EASTERN CORRIDOR SEGMENTS II AND III (PID 86461)  
**COMBINED LINWOOD/EASTERN INTERCHANGE AND US 50/RED BANK INTERCHANGE FOCUS AREA**  
**ADVISORY COMMITTEE MEETING #2**  
R.G. CRIBBET RECREATION CENTER • MAY 22, 2018

## MEETING #2 NOTES

**Figure X-2B-3 and EW-2**  
**GRADE SEPARATED INTERCHANGE TO CONNECT**  
**WILMER AVENUE TO WOOSTER ROAD**

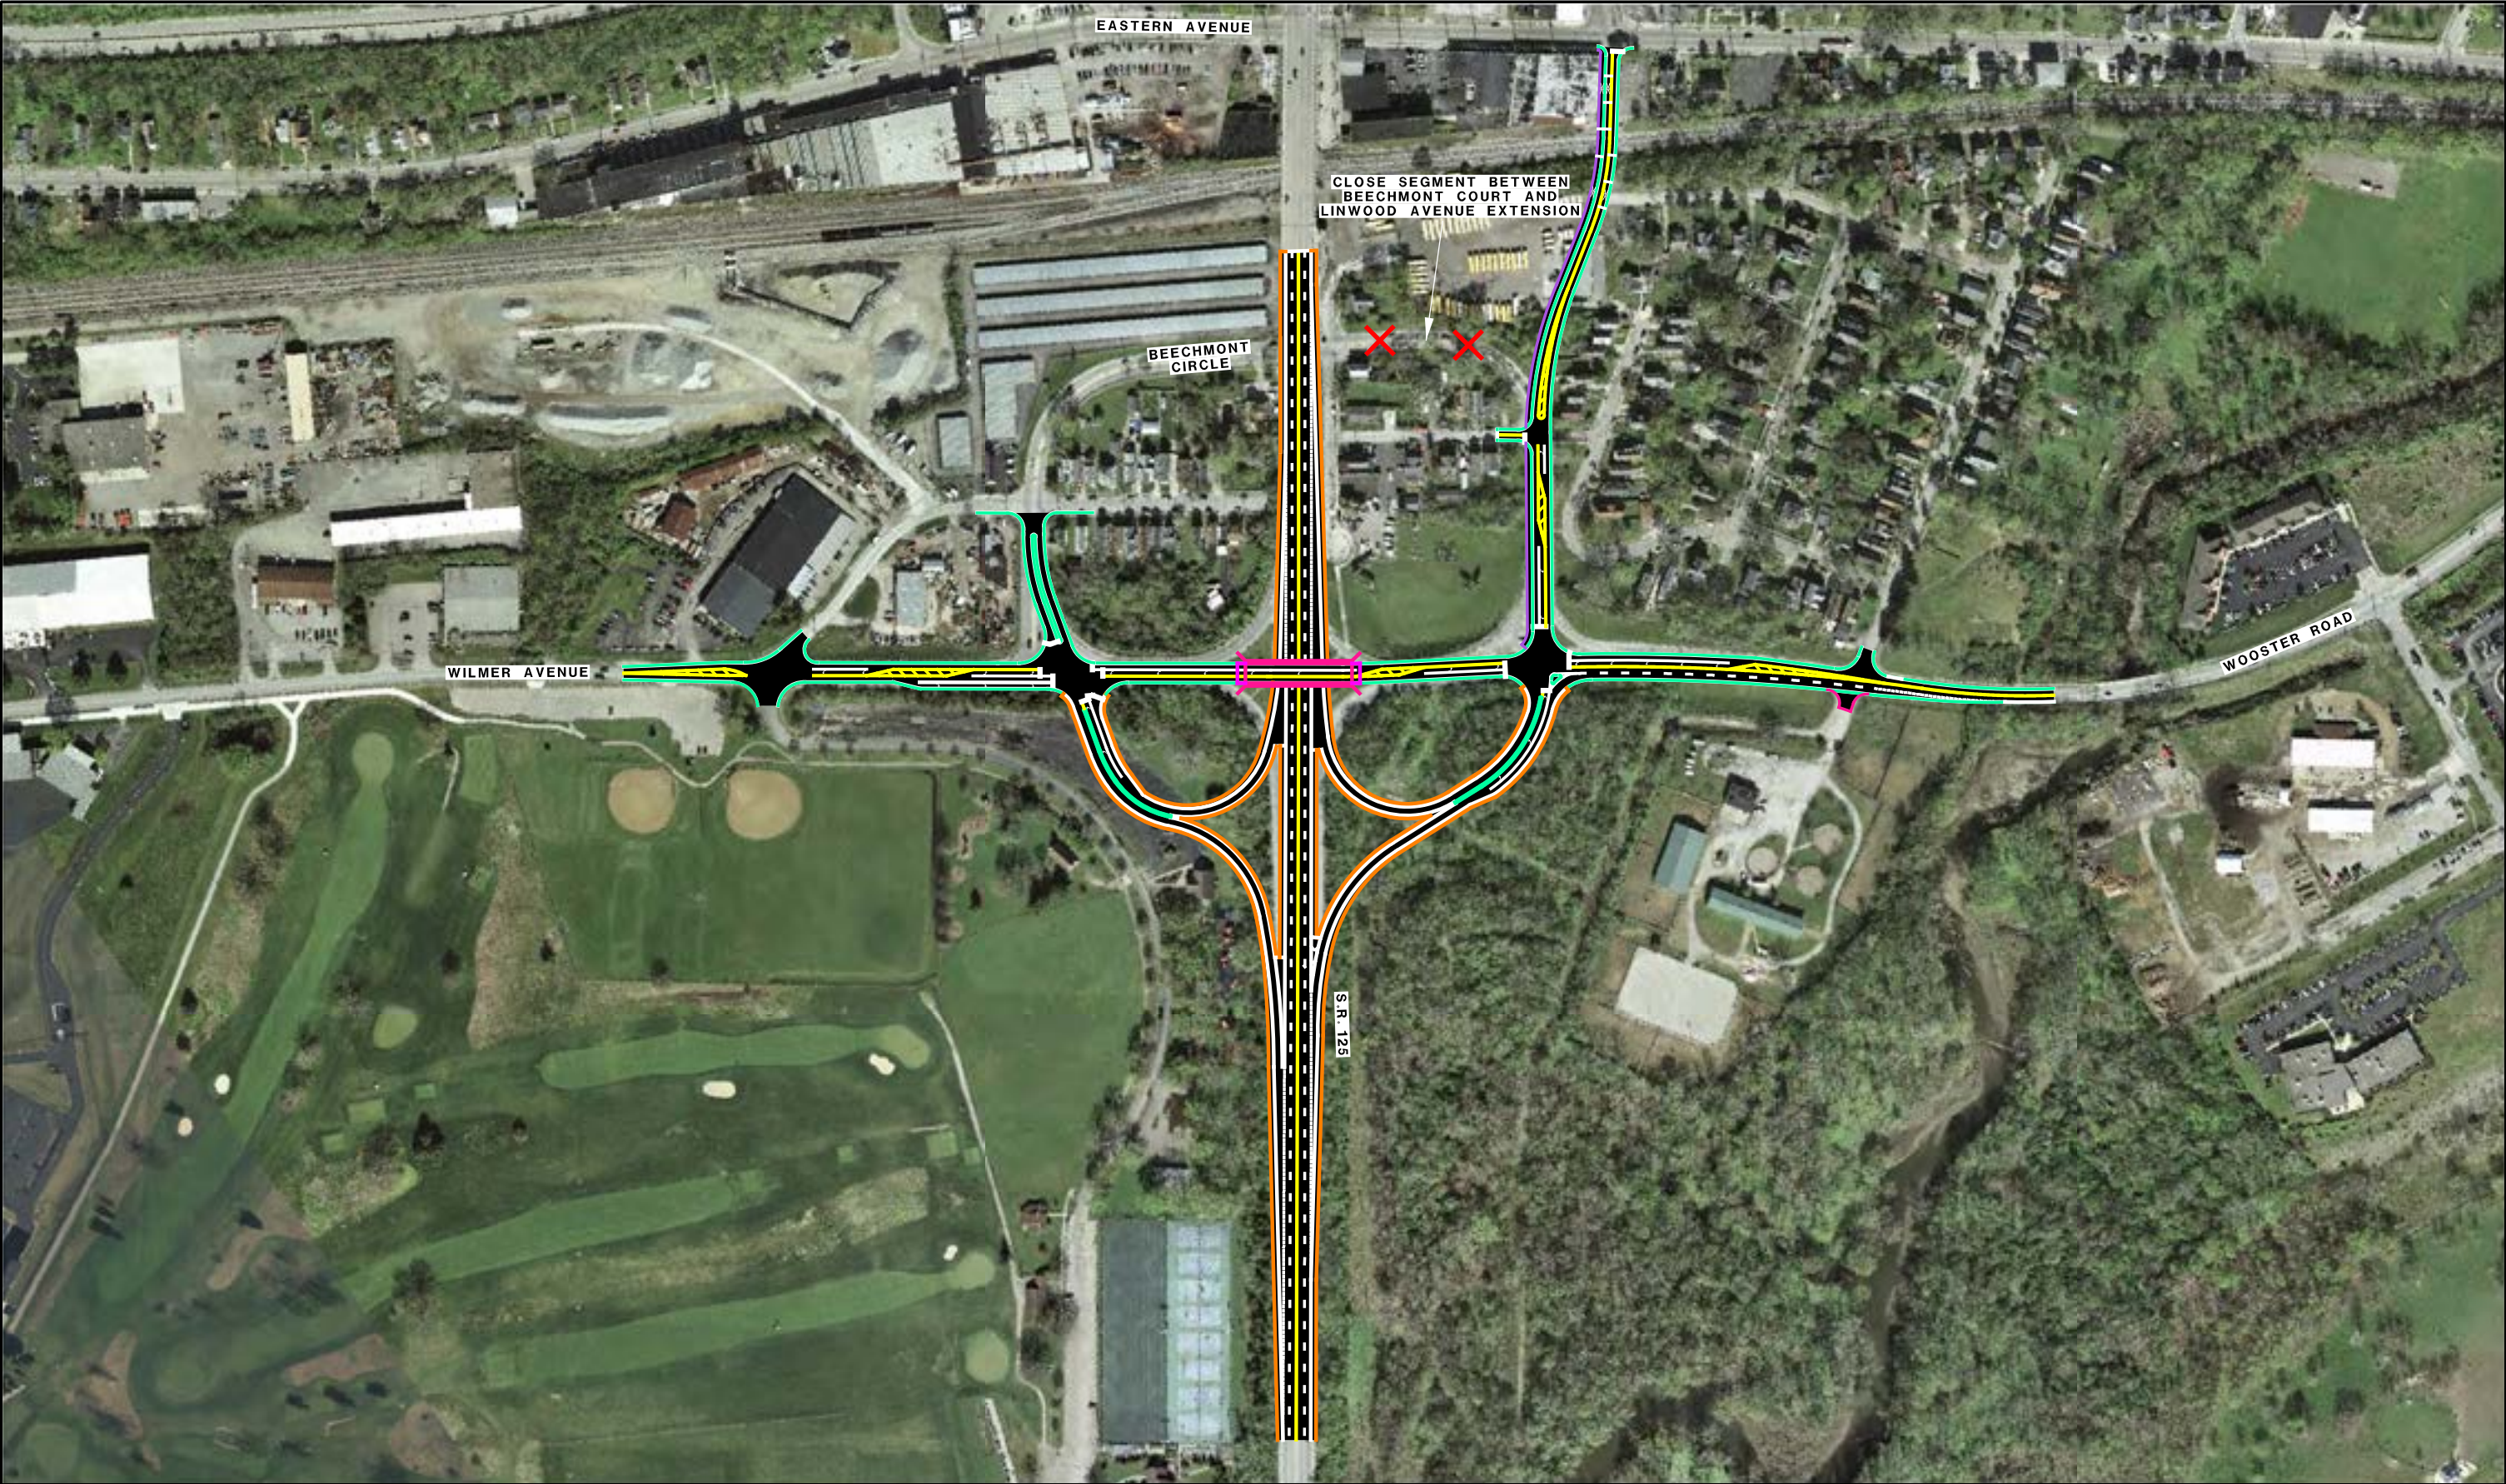
- The concept would take through traffic off Beechmont Circle and return the roads back to the neighborhood.
- New ramps from SR 125 to Wilmer and Wooster would impact properties south of Wilmer/Wooster
- Do not need “highway” type ramp connections at this location.

- (Comments are presented as submitted by Committee members; no edits to content were made.)*
- Will the 3 way intersections on either side (East and West) of the proposed grade change connection of Wilmer and Wooster be signalized, or stop signs? Concern this will slow flow of traffic compared to current design

- The intersections would either be signalized intersections or reconfigured into roundabouts.

**Figure X-2B-4**  
**GRADE SEPARATED INTERCHANGE TO CONNECT**  
**WILMER AVENUE AND WOOSTER ROAD**

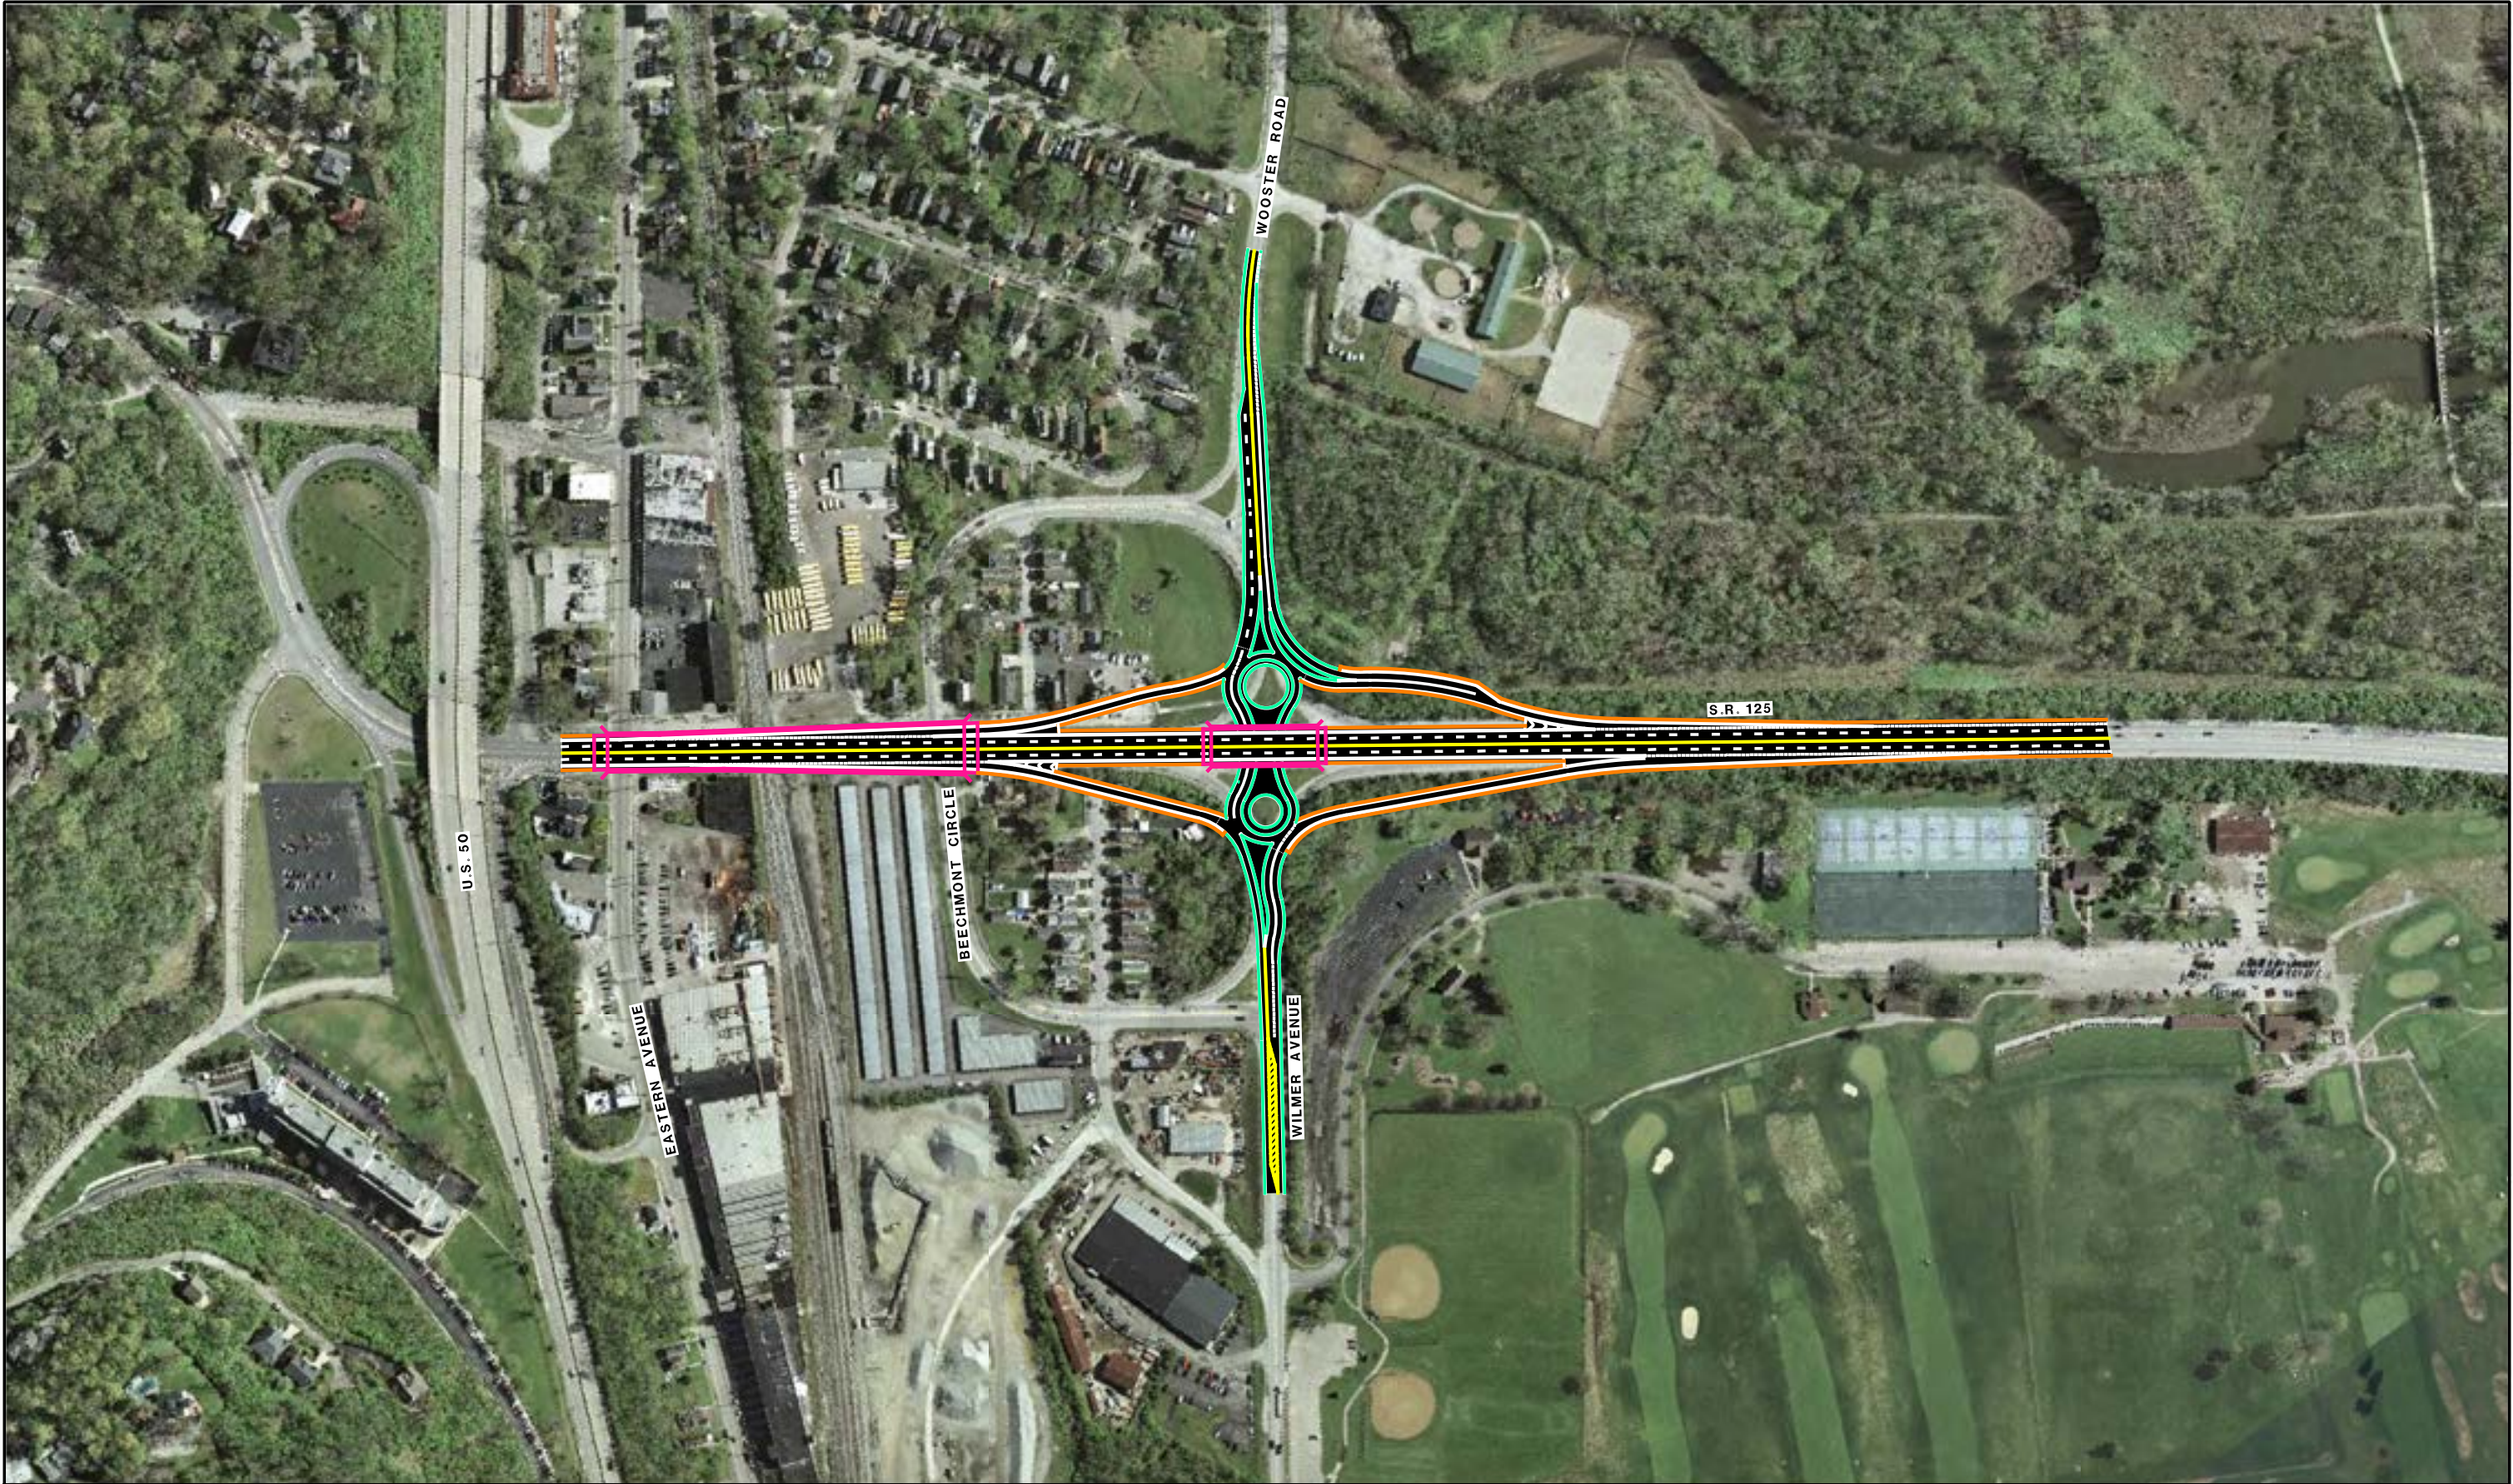
- This concept would require extra fill to raise the road over the Wilmer/Wooster connection.
- Requires replacement of the Beechmont Viaduct structure.

**Figure X-2B-5**  
**GRADE SEPARATED INTERCHANGE TO CONNECT**  
**WILMER AVENUE TO WOOSTER ROAD**

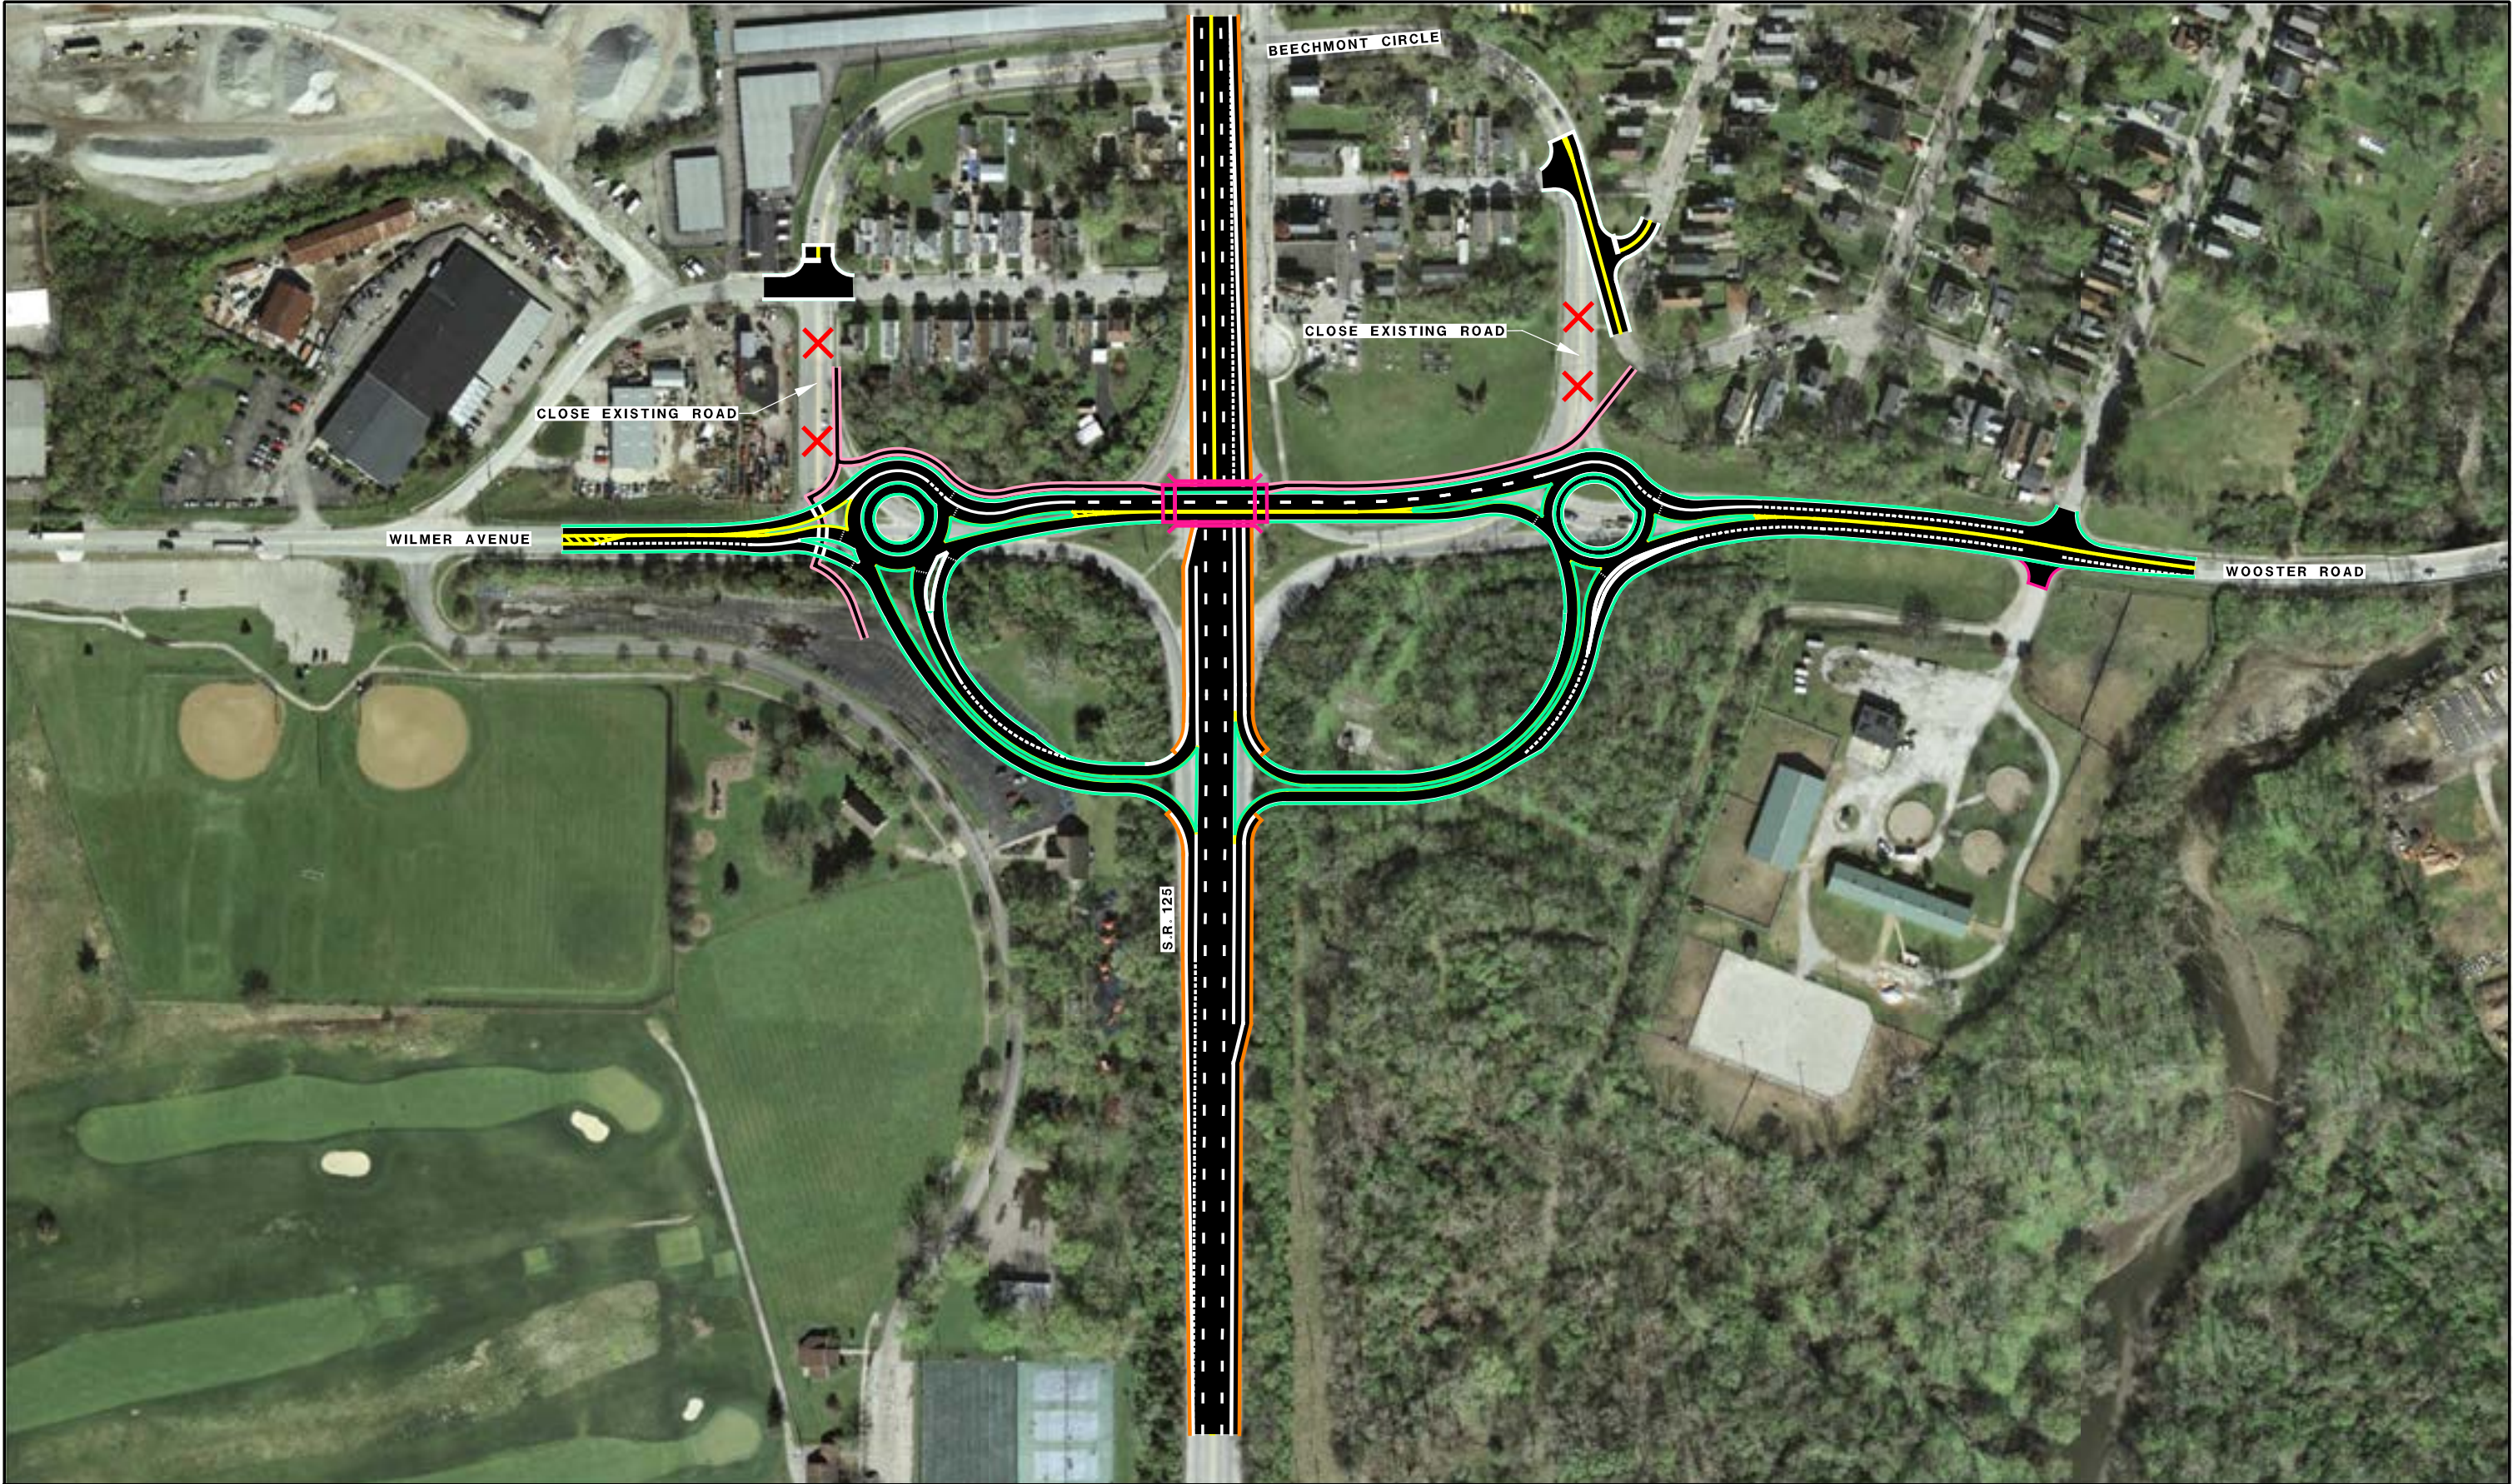
- Facilitates connections from SR 125 to Wilmer and to Wooster through the addition of new ramps.
- The new ramps from SR 125 to Wilmer and Wooster would impact properties south of Wilmer/Wooster.
- Roundabouts would be used to connect SR 125 with Wooster and Wilmer
  - Roundabouts calm traffic and allow for continuous flow
- Sidewalk connection would be included on the bridge over SR 125.
